CO 199 Bikeway

Concept Design Validation Memo

Appendix A Concept Plan Mark-Up

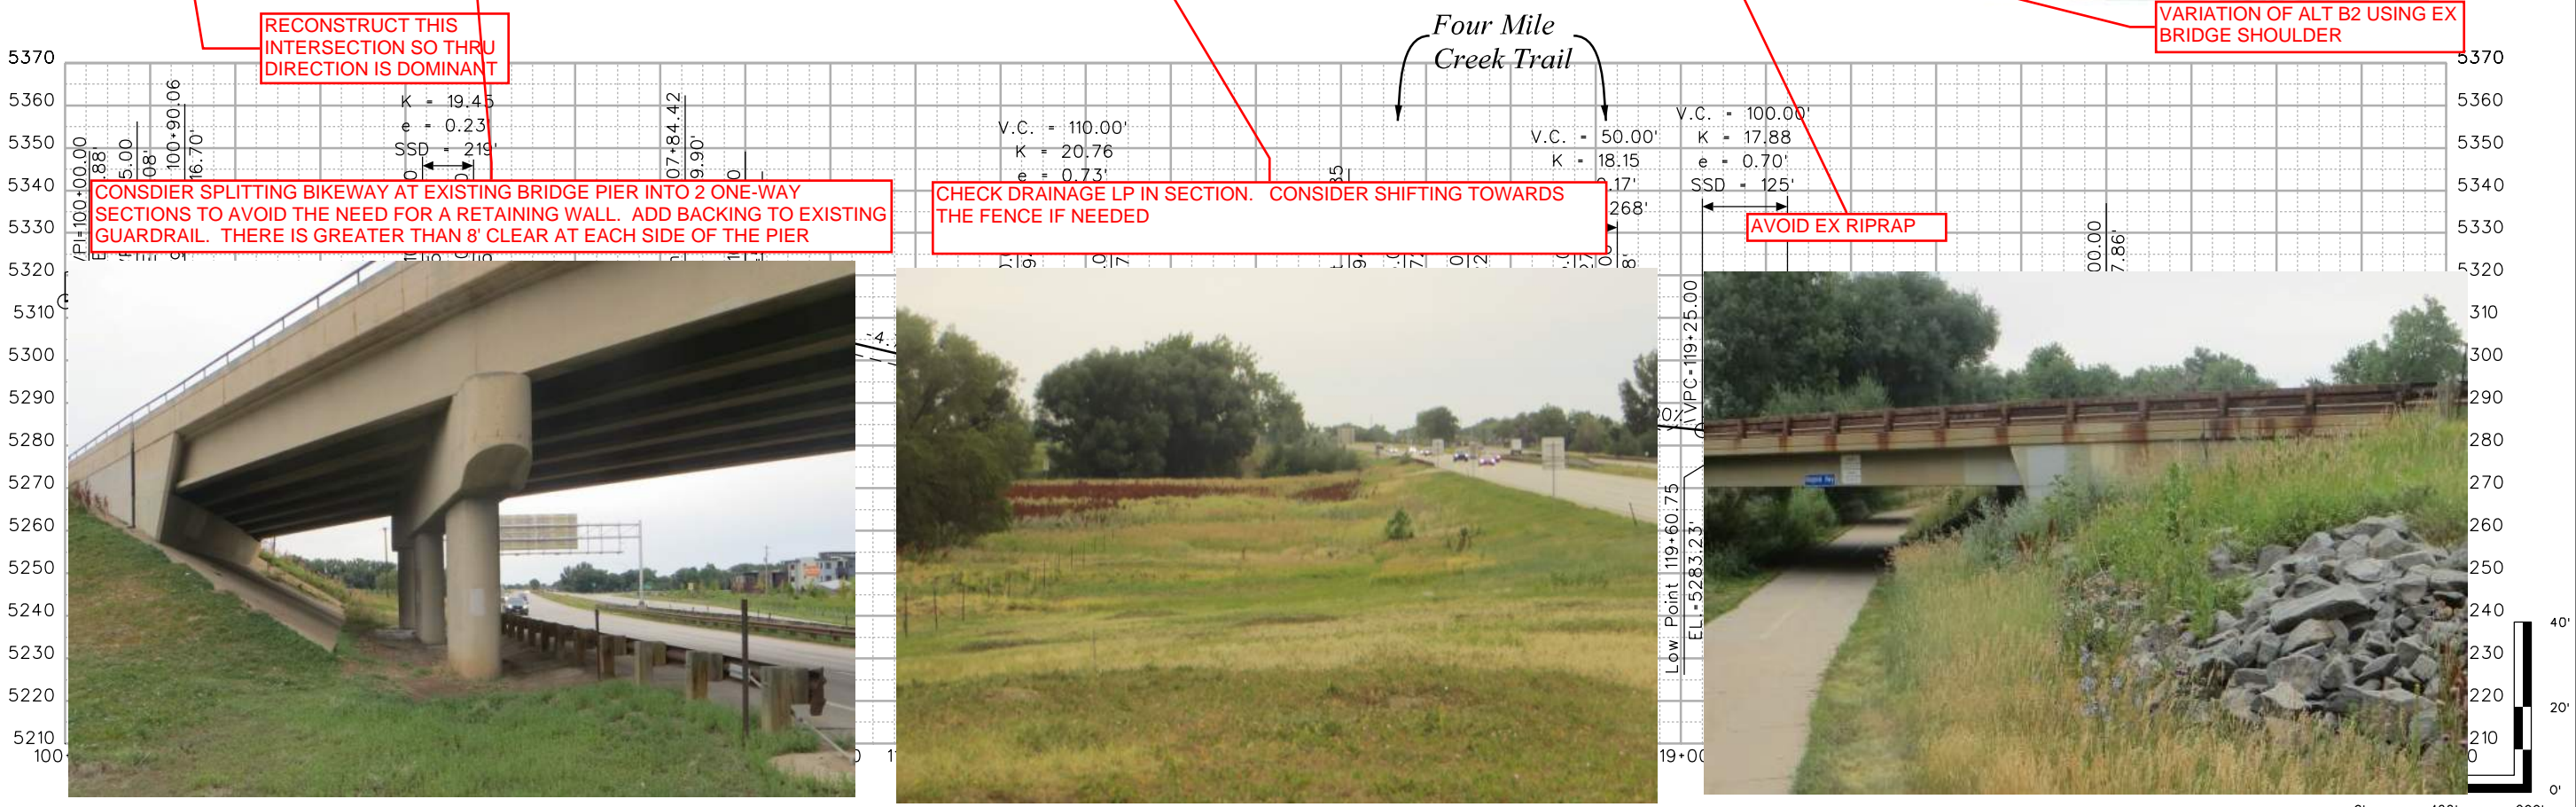
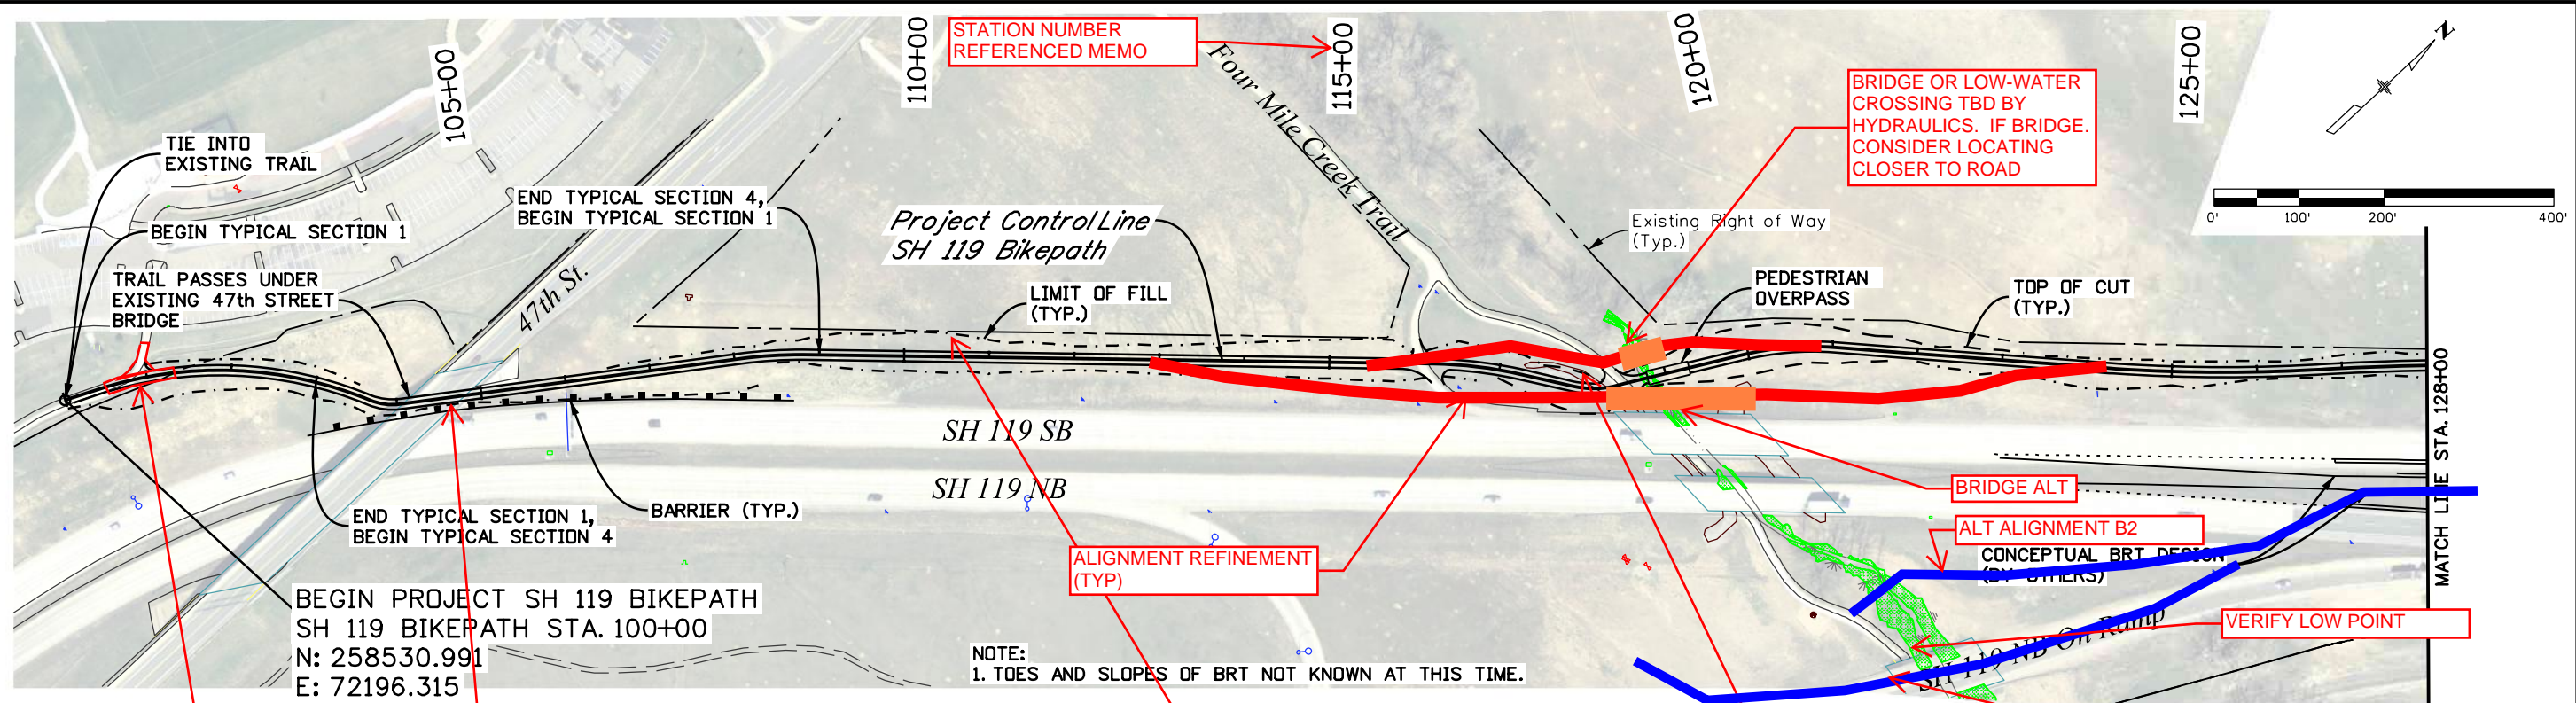
RECONSTRUCT THIS INTERSECTION SO THRU DIRECTION IS DOMINANT

CONSIDER SPLITTING BIKEWAY AT EXISTING BRIDGE PIER INTO 2 ONE-WAY SECTIONS TO AVOID THE NEED FOR A RETAINING WALL. ADD BACKING TO EXISTING GUARDRAIL. THERE IS GREATER THAN 8' CLEAR AT EACH SIDE OF THE PIER

CHECK DRAINAGE LP IN SECTION. CONSIDER SHIFTING TOWARDS THE FENCE IF NEEDED

AVOID EX RIPRAP

VARIATION OF ALT B2 USING EX BRIDGE SHOULDER

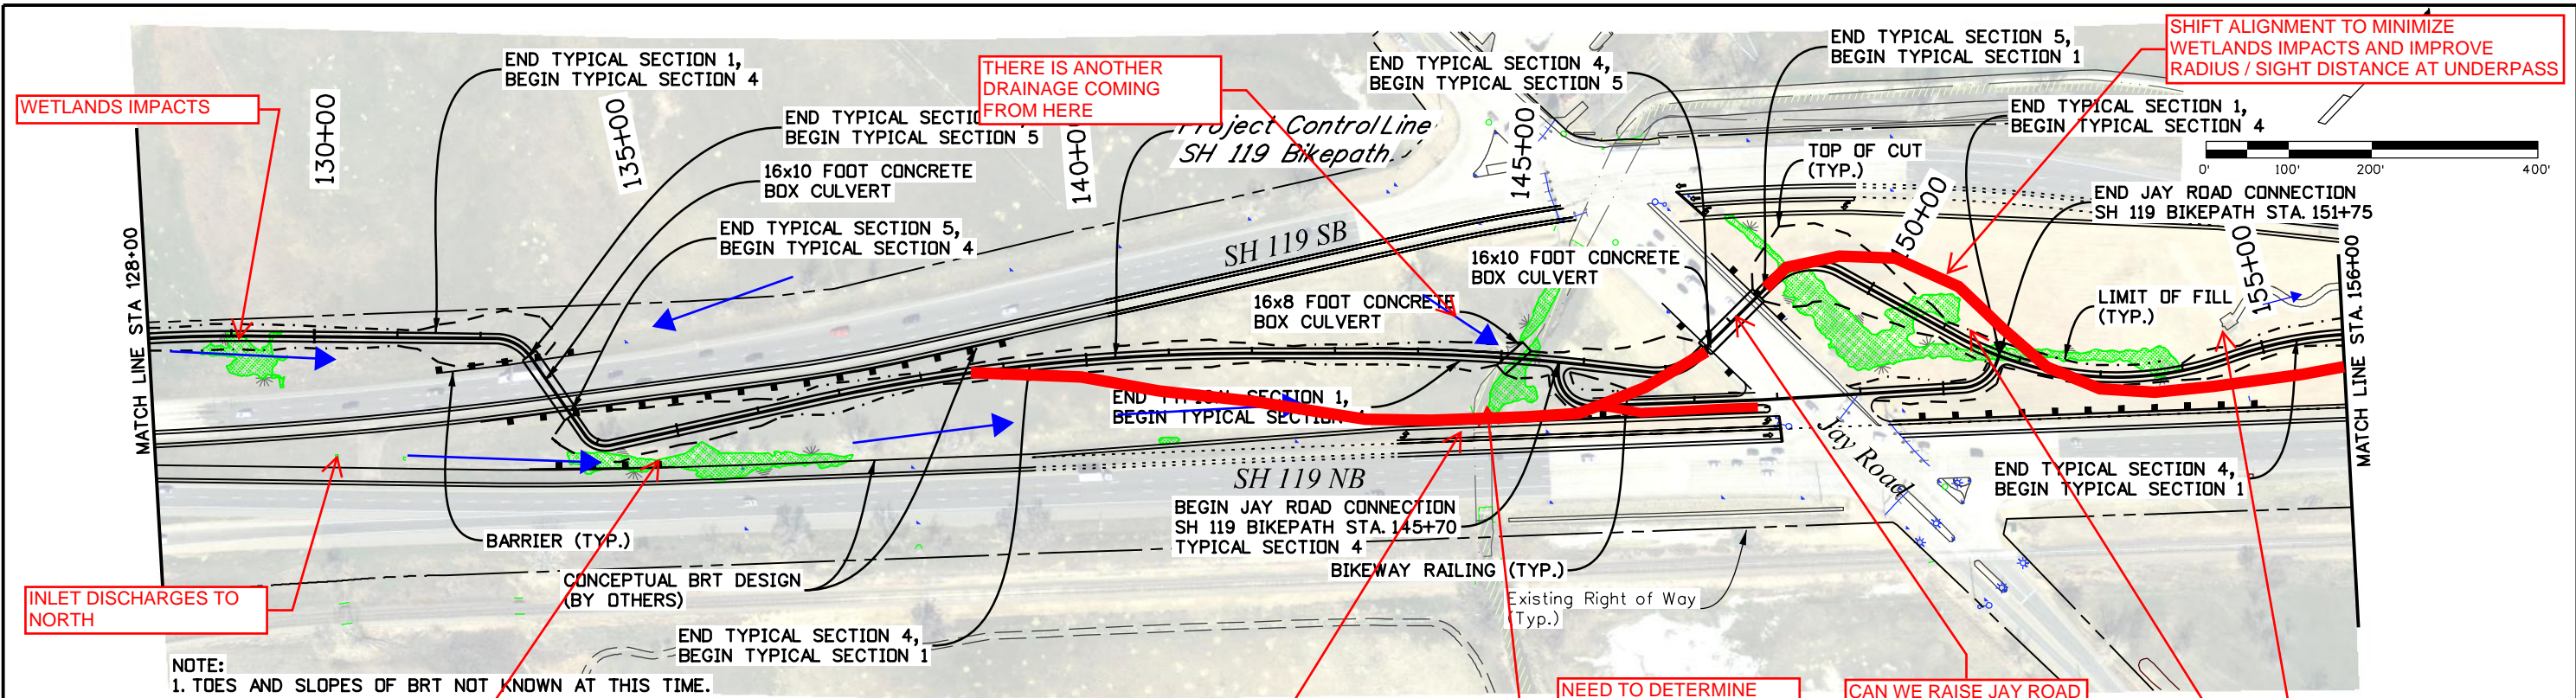
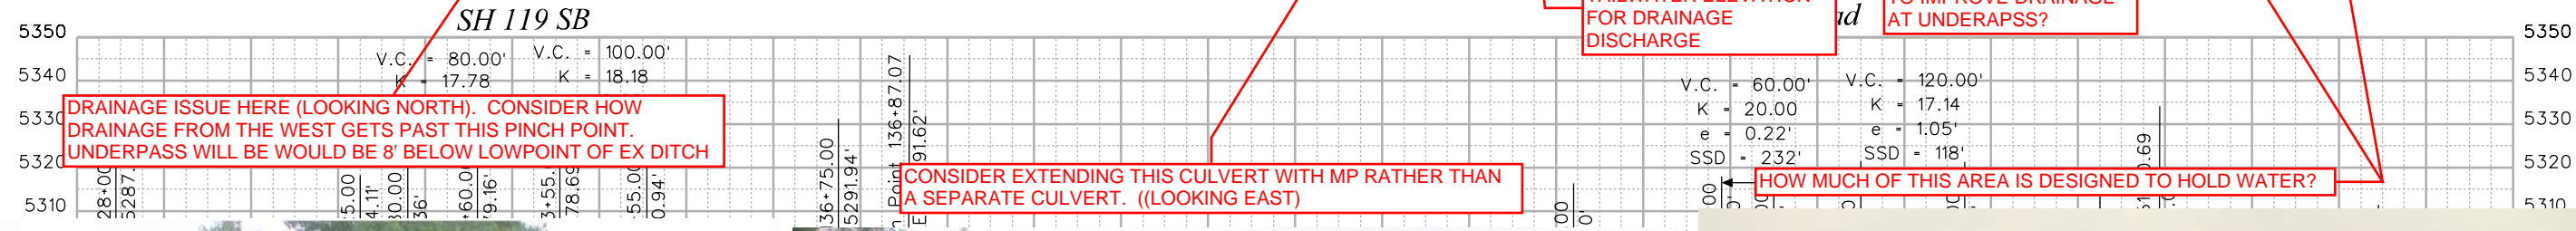
DRAINAGE ISSUE HERE (LOOKING NORTH). CONSIDER HOW DRAINAGE FROM THE WEST GETS PAST THIS PINCH POINT. UNDERPASS WILL BE 8' BELOW LOWPOINT OF EX DITCH

CONSIDER EXTENDING THIS CULVERT WITH MP RATHER THAN A SEPARATE CULVERT. ((LOOKING EAST))

HOW MUCH OF THIS AREA IS DESIGNED TO HOLD WATER?

Print Date: 8/5/2021	
Drawing File Name: 22455DES_Plan04.dgn	
Horiz. Scale: 1:200	Vert. Scale: As Noted
Unit Information	Unit Leader Initials
MULLER ENGINEERING COMPANY

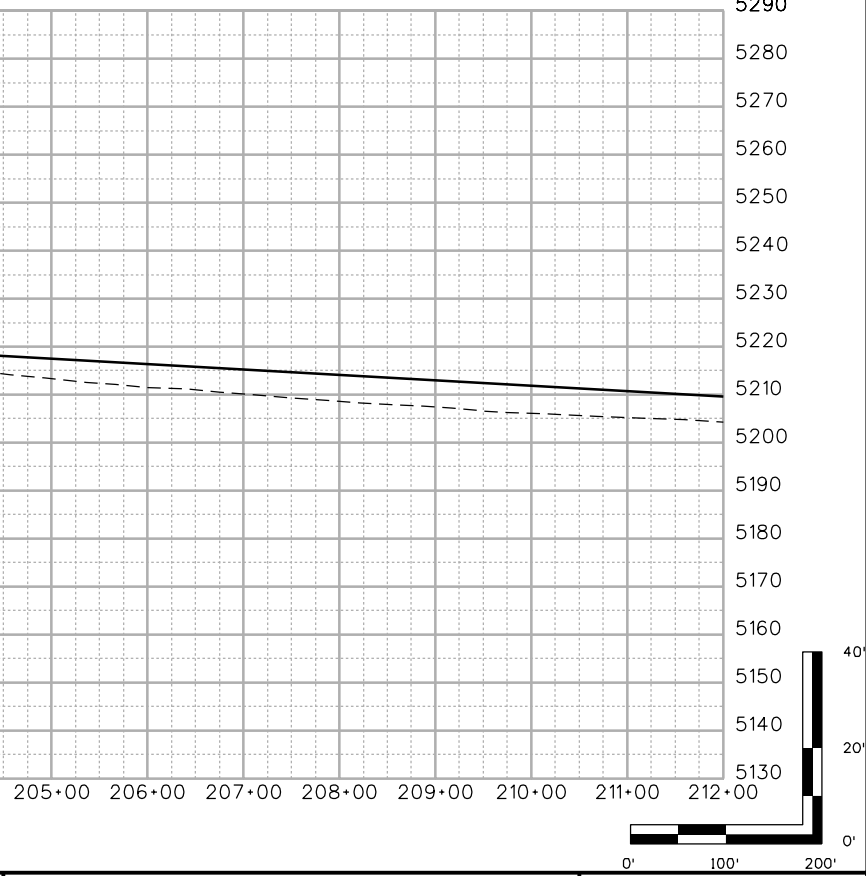
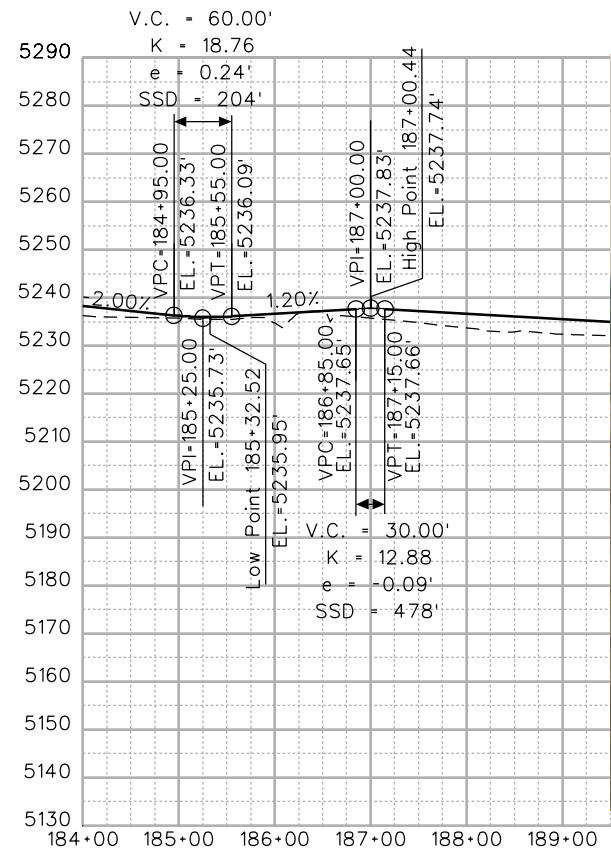
ALIGNMENT GOOD AS-IS. TERRAIN IS FLAT AND WIDE OPEN WITH NO TREES OR WETLANDS

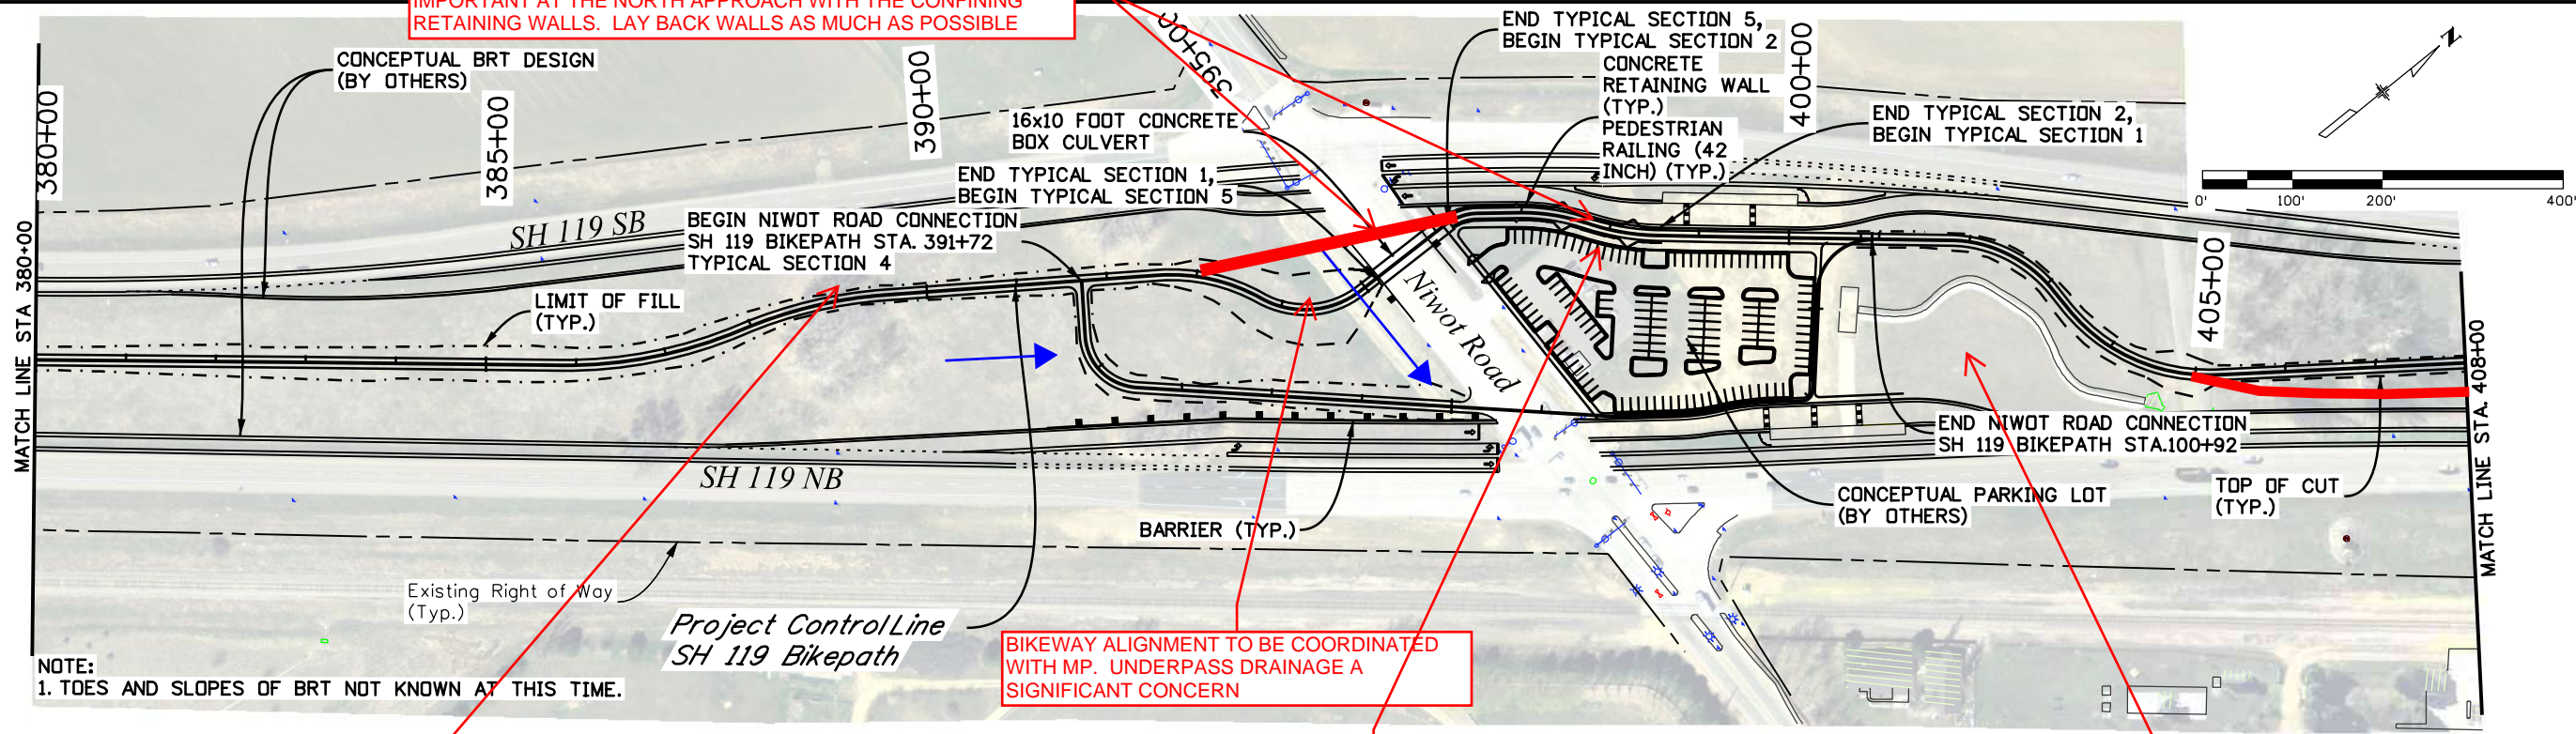
INCREASE SKEW OF UNDERPASS TO IMPROVE SIGHT LINES AT BOTH SIDES OF THE UNDERPASS. THIS WILL BE ESPECIALLY IMPORTANT AT THE NORTH APPROACH WITH THE CONFINING RETAINING WALLS. LAY BACK WALLS AS MUCH AS POSSIBLE

BIKEWAY ALIGNMENT TO BE COORDINATED WITH MP. UNDERPASS DRAINAGE A SIGNIFICANT CONCERN

VERIFY THAT ALIGNMENT AVOIDS IMPACTS TO TALL COTTONWOODS

SOIL AND VEGETATION SHOWS SIGNS OF STANDING WATER WHERE THE UNDERPASS IS PROPOSED
